**Intermountain Power Service Corp.  
ABT Siemens Warranty Claim**

Unit #2 - 950 MW

Plant Location – Delta Utah

Date: October 17, 2007

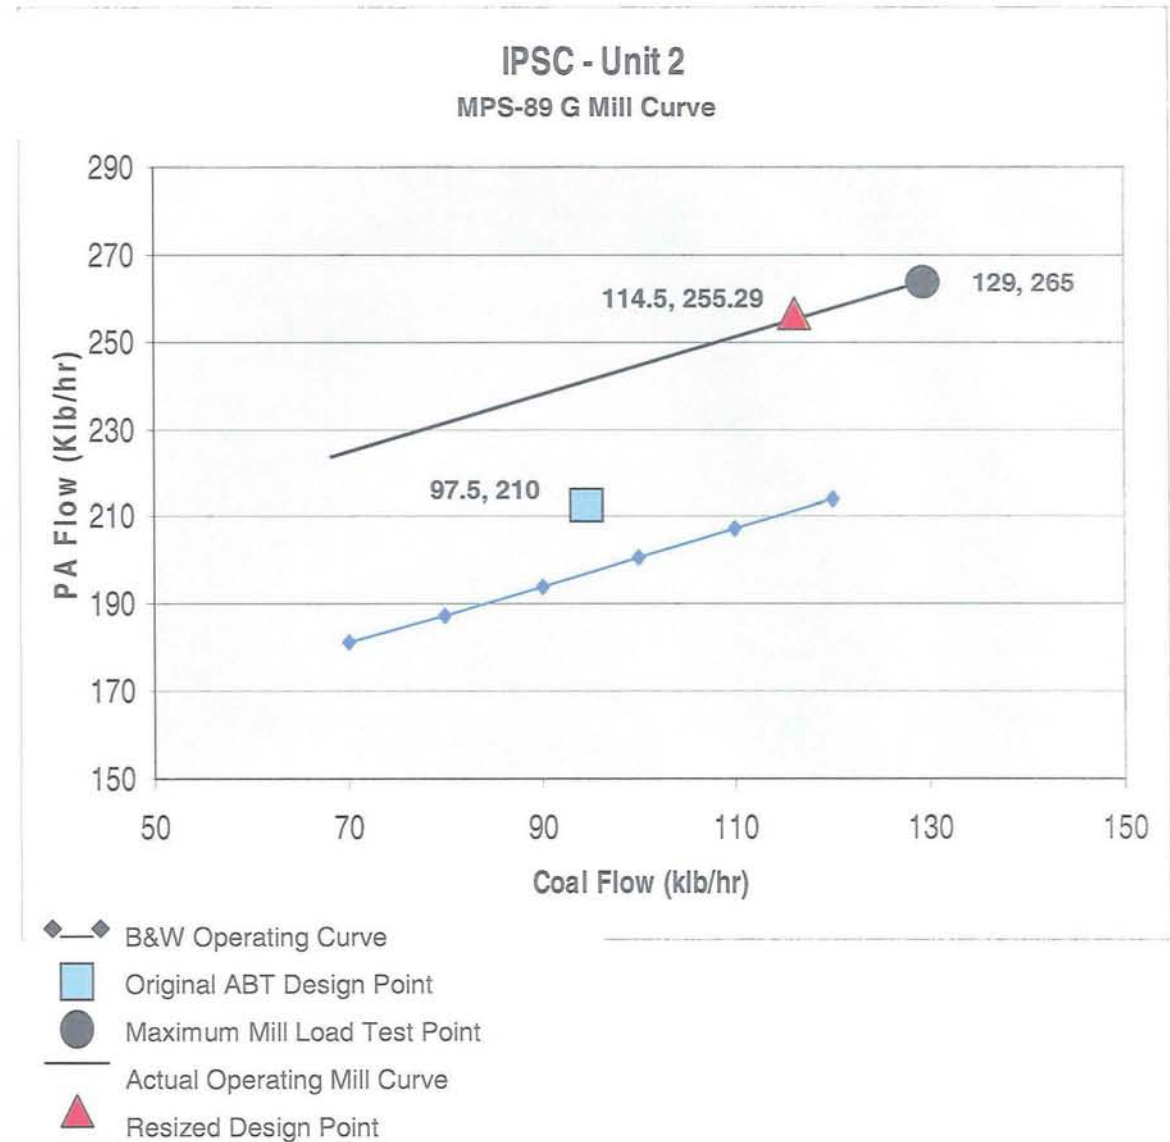
Erosion is originating at the transition slope from the round barrel to the 6 lobe exit. This is consistent with the results of the CFD model. The metallurgical analysis performed by Tordonato Energy Consultants identified erosion as a the contributor cause of the nozzle cracking. The high temperatures at the weld between the nozzle and burner barrel increased the stress which also contributed to the cracking. There was no evidence of corrosion.

The revised fuel injector design will increase the cross sectional area of the nozzle to reduce velocities, lengthen and flatten the slope of the transition ramp and replace the round elbow with a "Flat back" design to allow dispersion of the coal particles across the flow area of the nozzle.

Contours of Static Temperature (f)

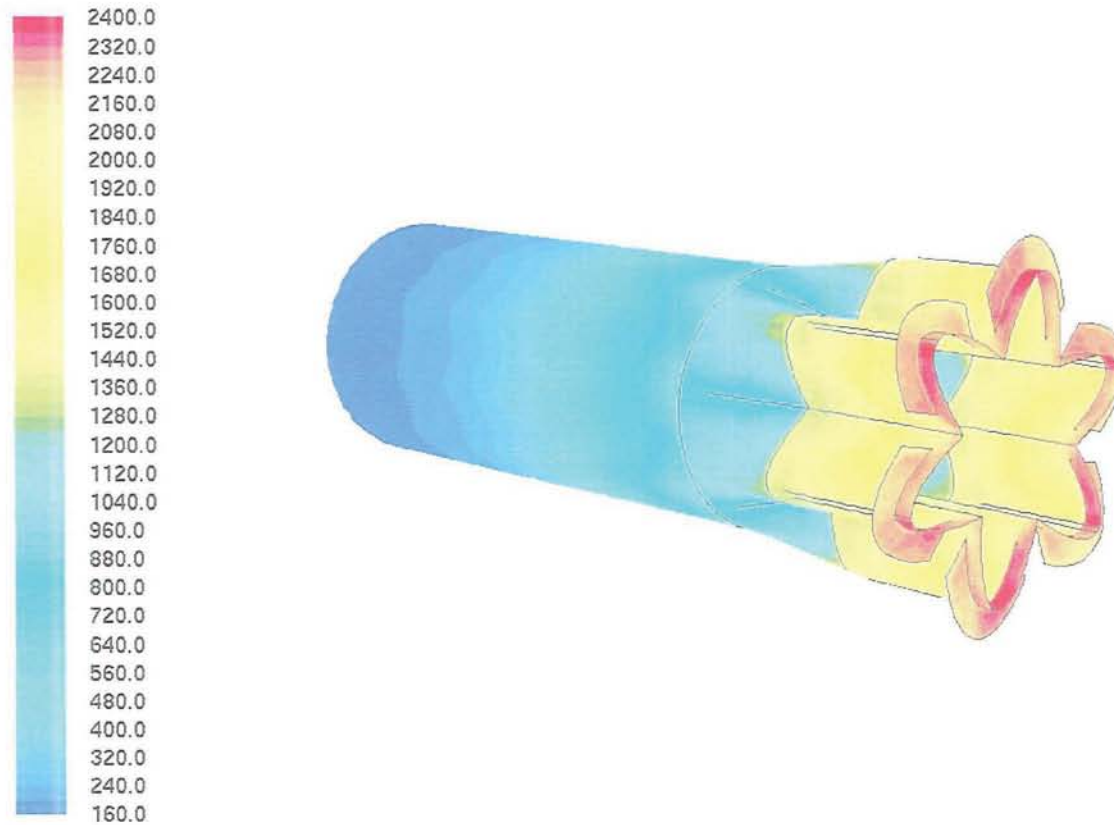
The furnace radiation model shows that the heat conducted back to the burner barrel to be higher than expected. The revised fuel injector will use a spool piece of 253MA stainless steel to make the transition from the nozzle to the barrel. The revised fuel injector shall use refractory tile to shield the burner barrel from radiation from the furnace and to minimize erosion. This thermal model does not model the cooling of the secondary air on the tip.
